Addendum No. 1

Project Name: N5001(1)1,2&4 Road Improvement Project in Toadlena/Two Grey Hills, NM

Owner: Navajo Division of Transportation

3. Plans: Sheets 98-102 have been revised to clarify dimensions for Bridge N213 per question received. Replace plan sheets 98-102 and refer to the question-and-answer section.

**GRS-IBS
PLAN AND ELEVATION**

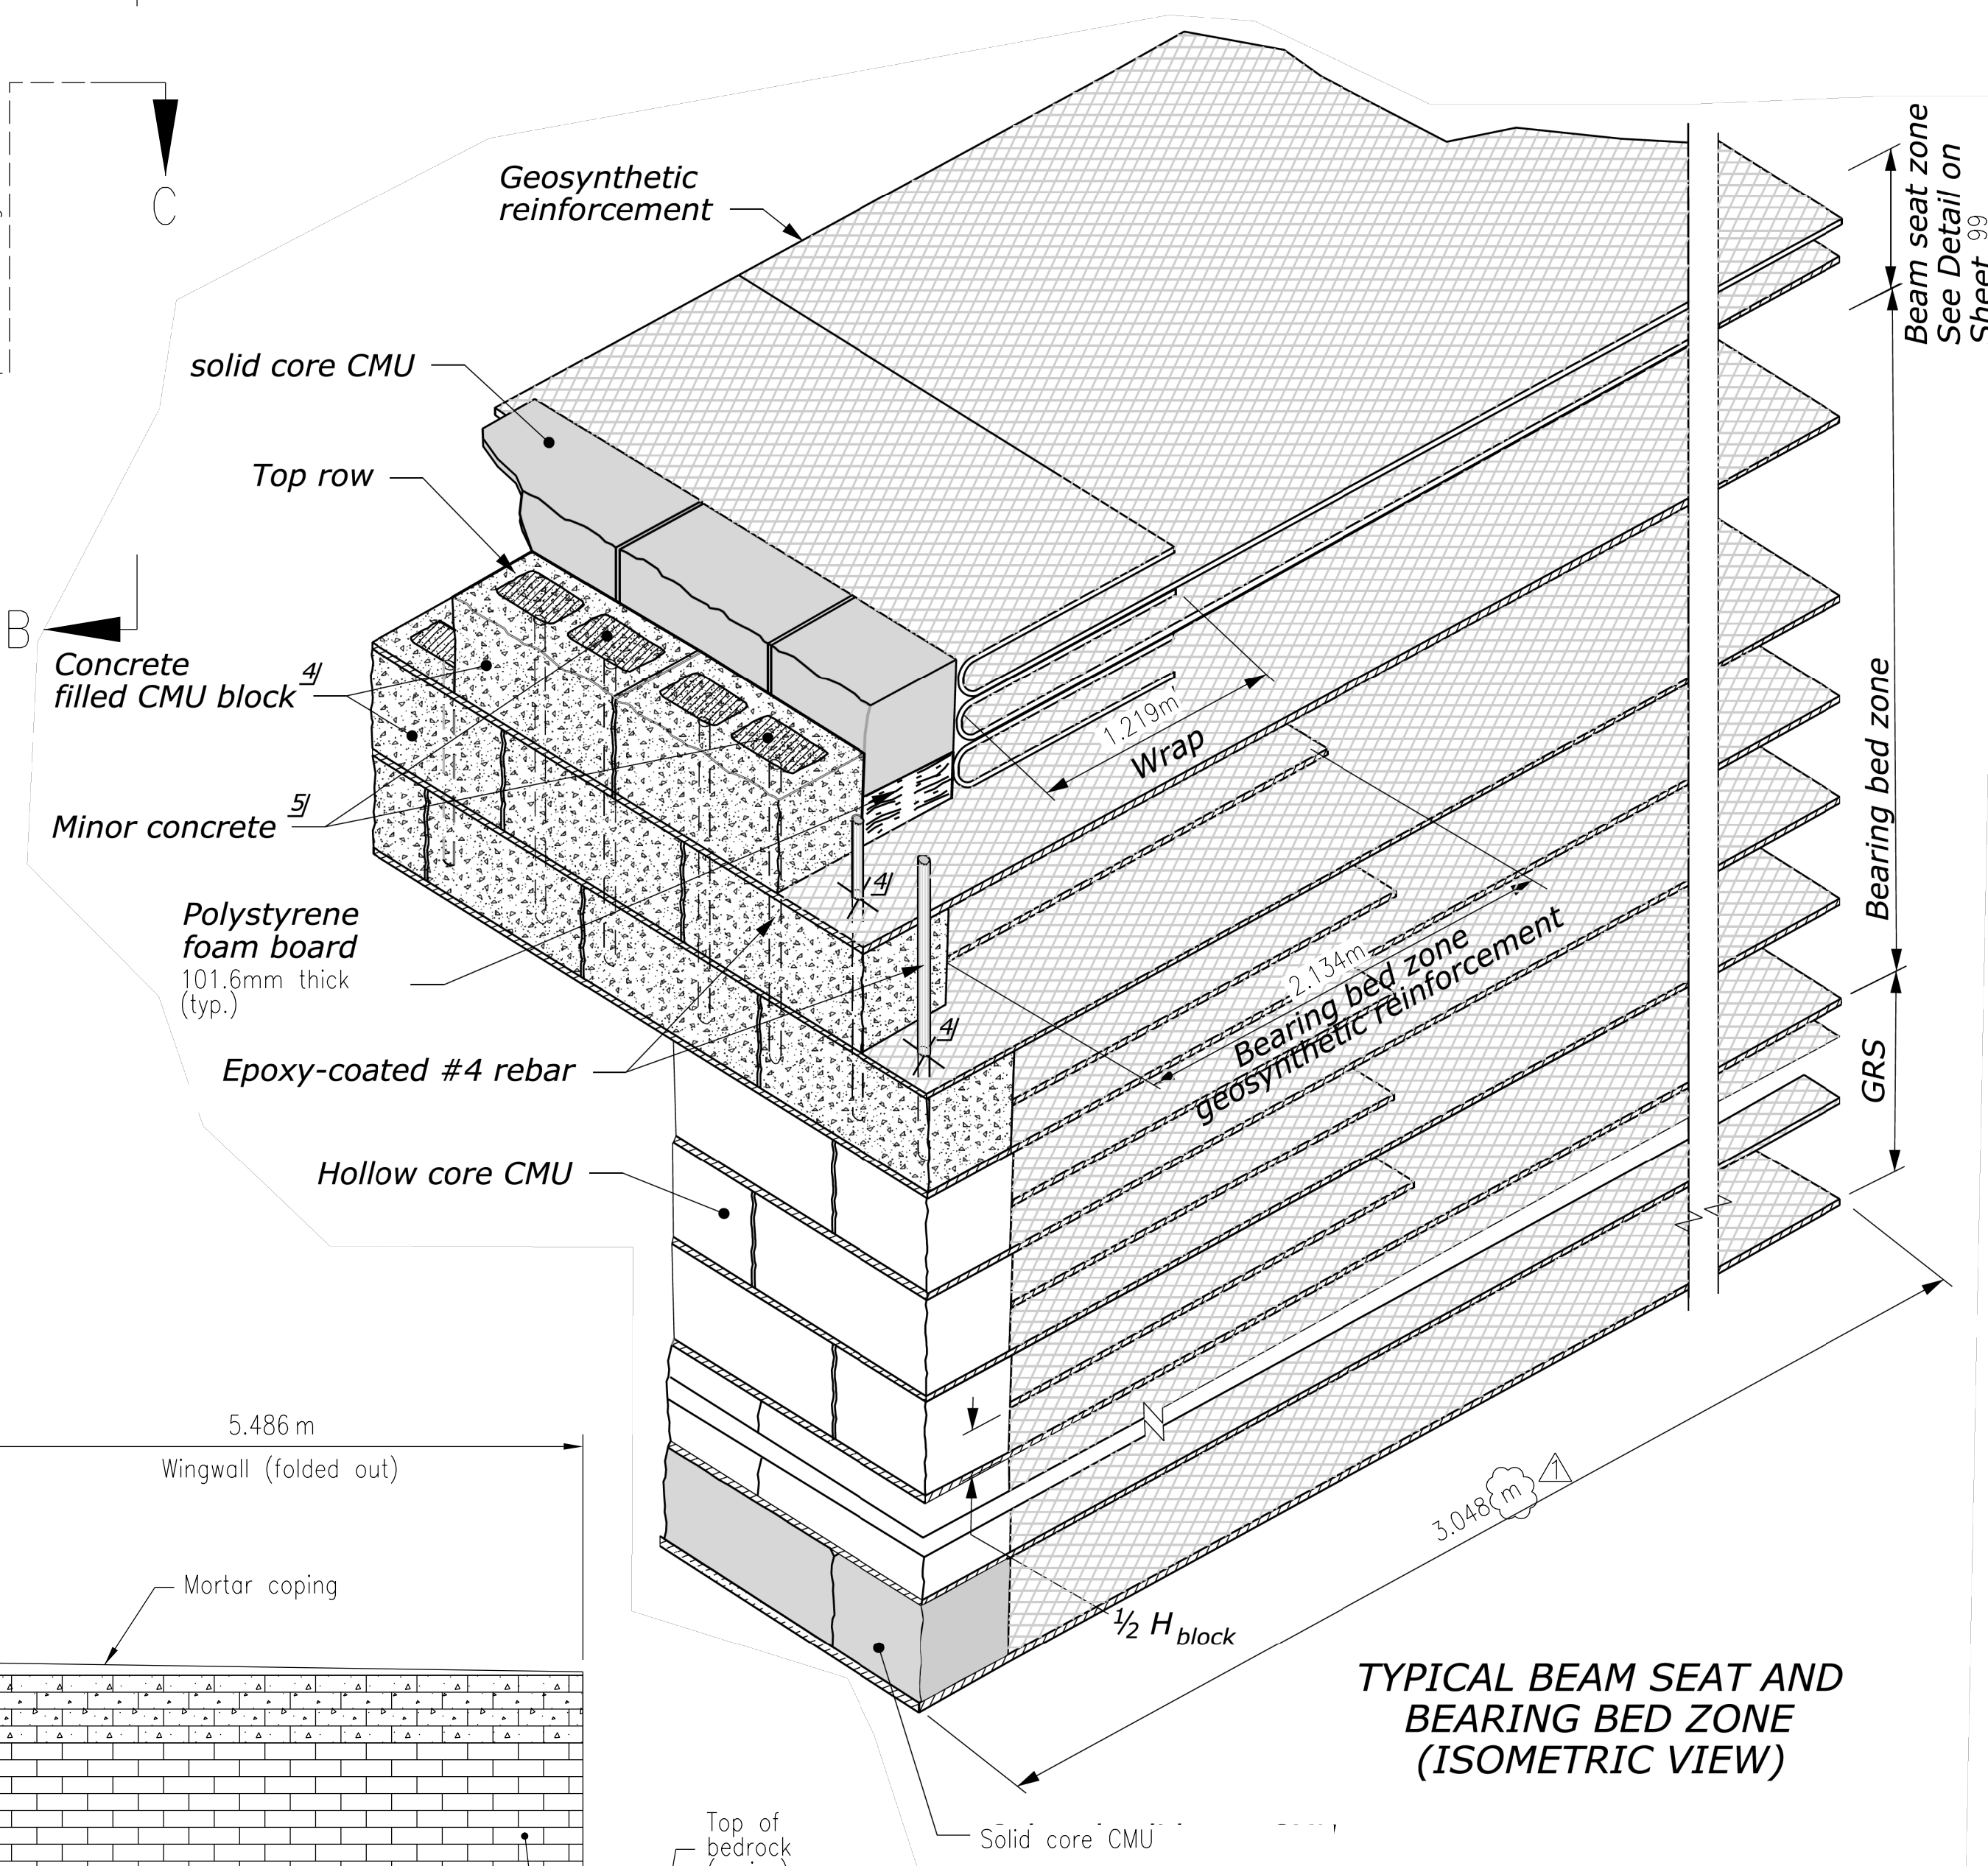
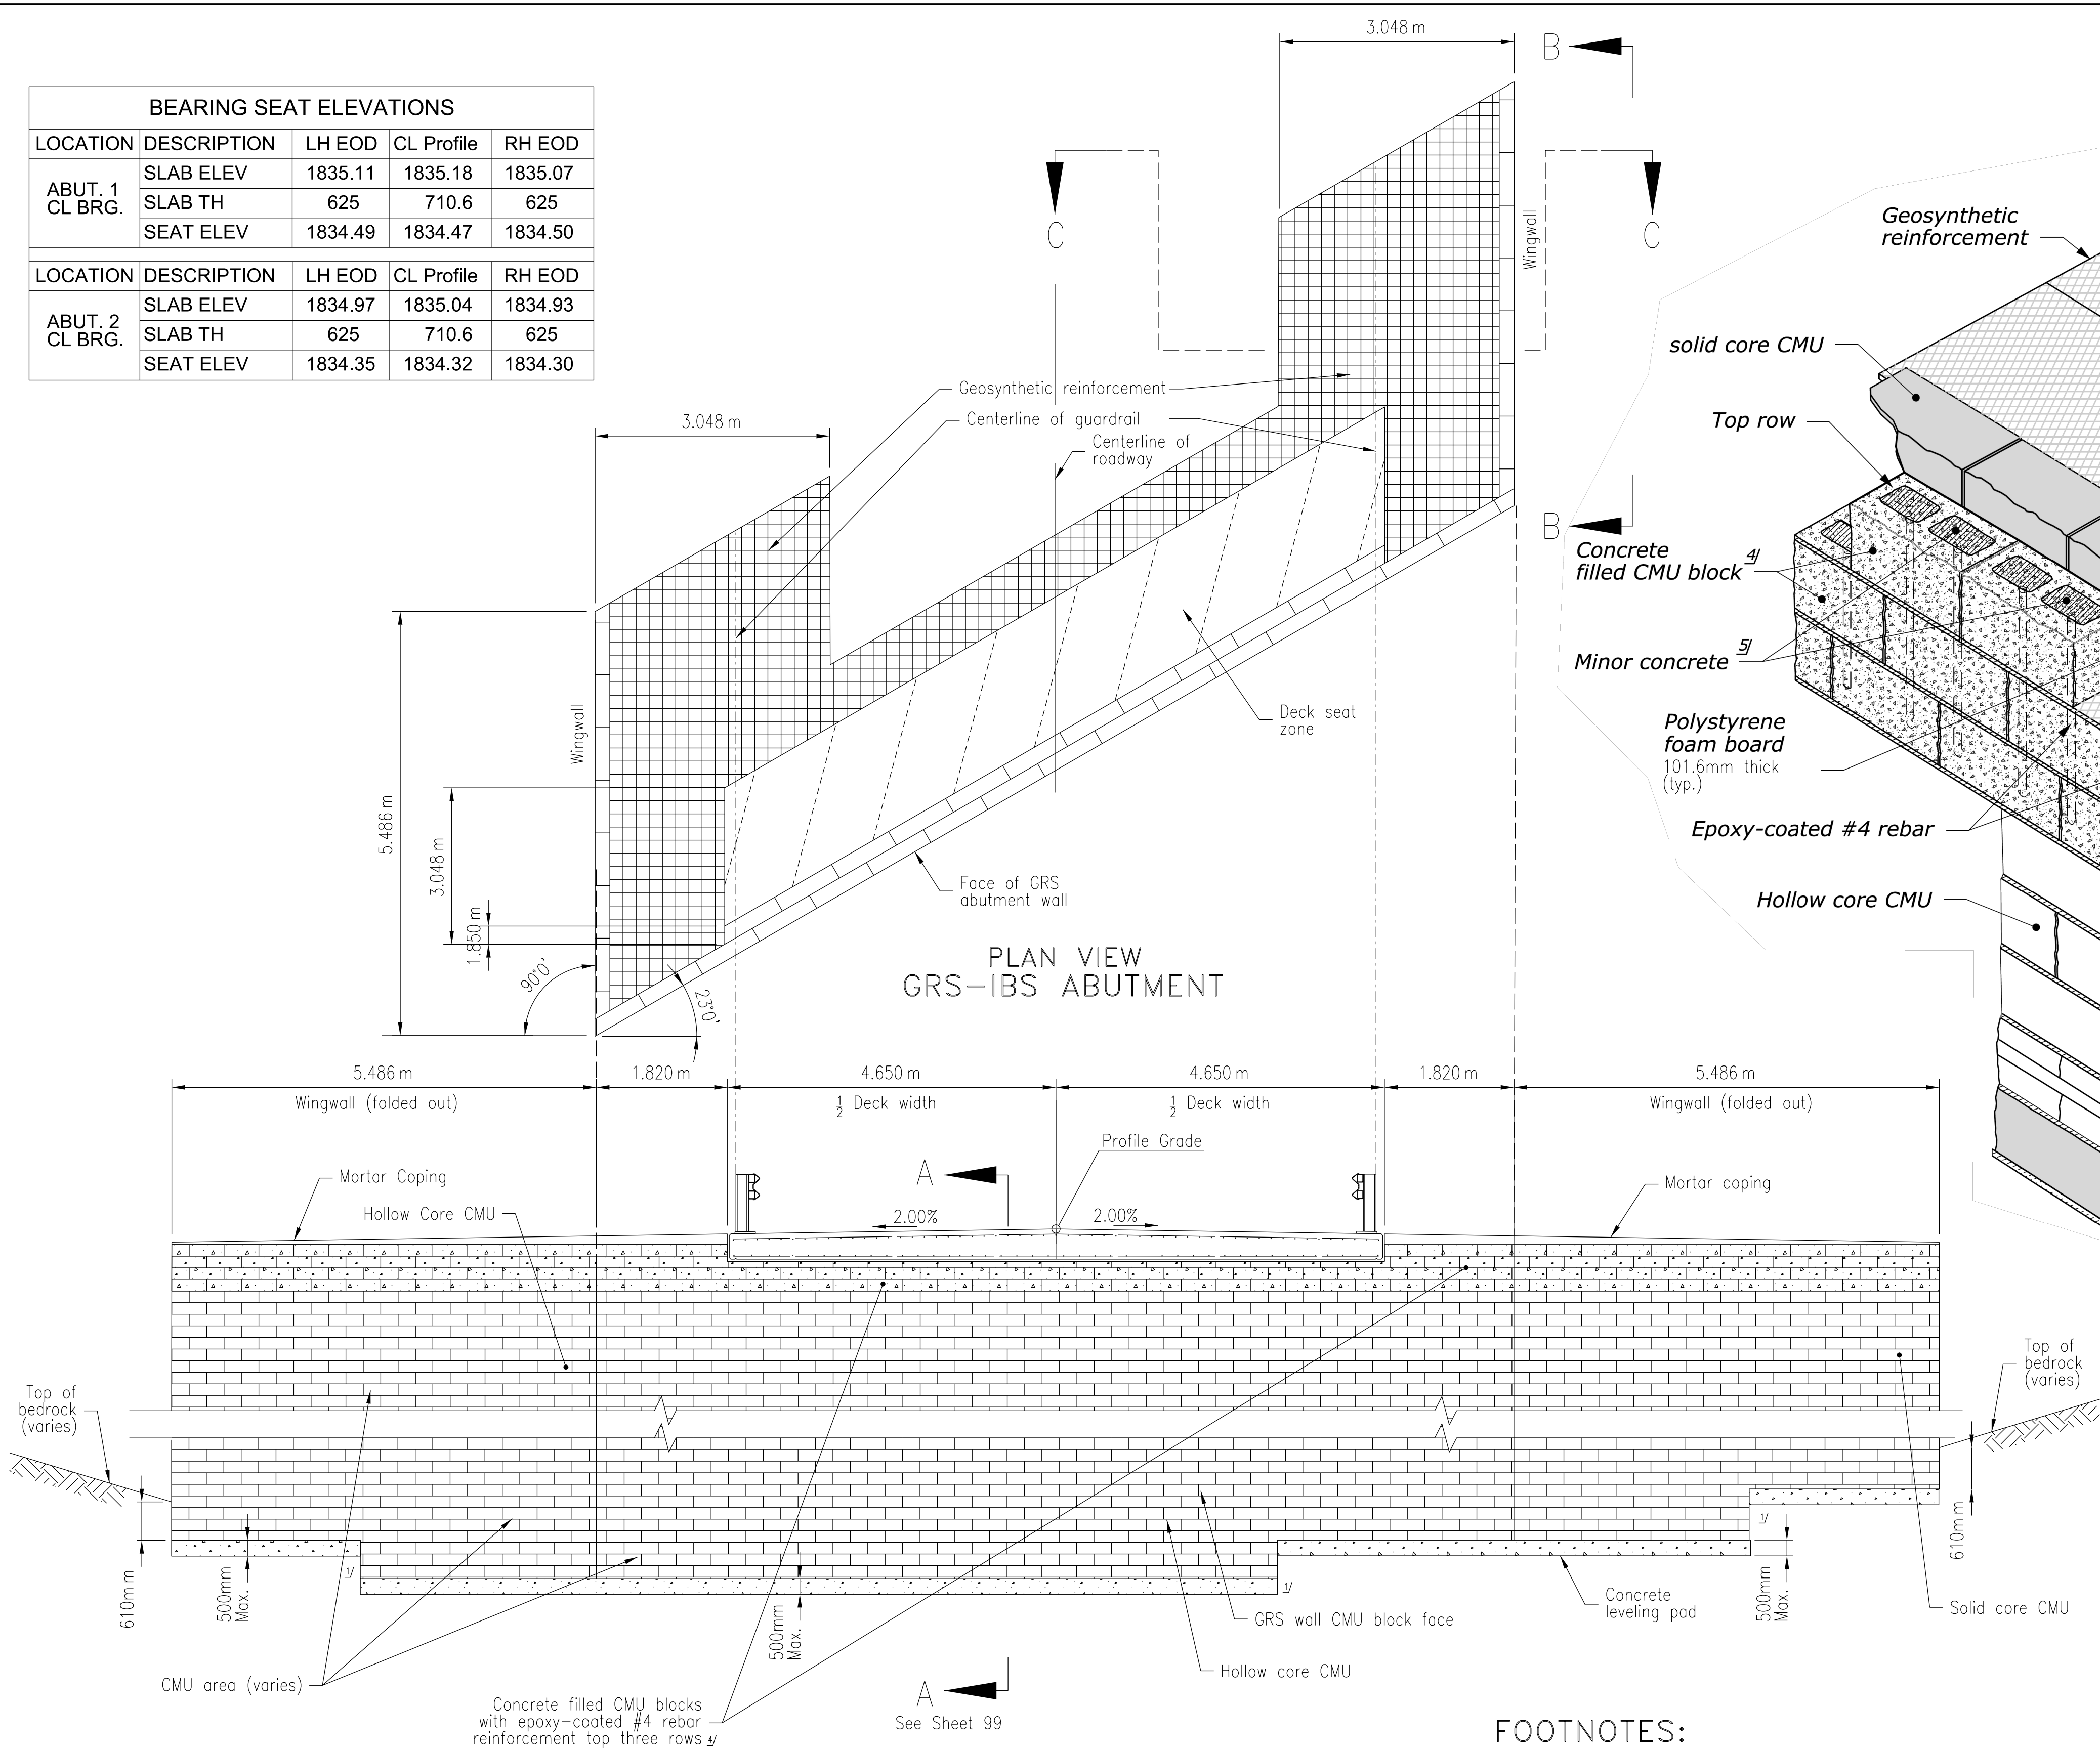
<p>Will the department please verify the dimensions of the concrete leveling pad on structure 213. Plan sheet 99 is showing a width of 2.820 Meters. Additionally, the height of the leveling pad is referenced as</p>	<p>The depth of the leveling pad is to be 0.203m minimum to 0.500m maximum. The width of the leveling pad is to be 0.457m.</p>

.203 M on sheet 99 and on sheet 98 it is referenced as 500 MM max.	Plan sheets 98 thru 101 have been revised to reflect these dimension clarifications.
Will the department please provide a breakdown of the items that are to be paid for under bid item 20304-1000 (Removal of structures and Obstructions).	See the attached table of items that are to be included in Bid Item 20304-1000 Removal of Structures and Obstructions.
Note 8 (Removal of Existing Bridge) on plan sheet 93 of the project plans states that the contractor shall remove, clean and stockpile all existing salvageable material. Will the department please provide a list of the material that is to be salvaged for both bridges.	Contractor is not to salvage any of the bridge components. Contractor to remove and dispose of all existing bridge components. Please reference Plan Sheet 3, General Note 20 for additional direction on salvageable items.
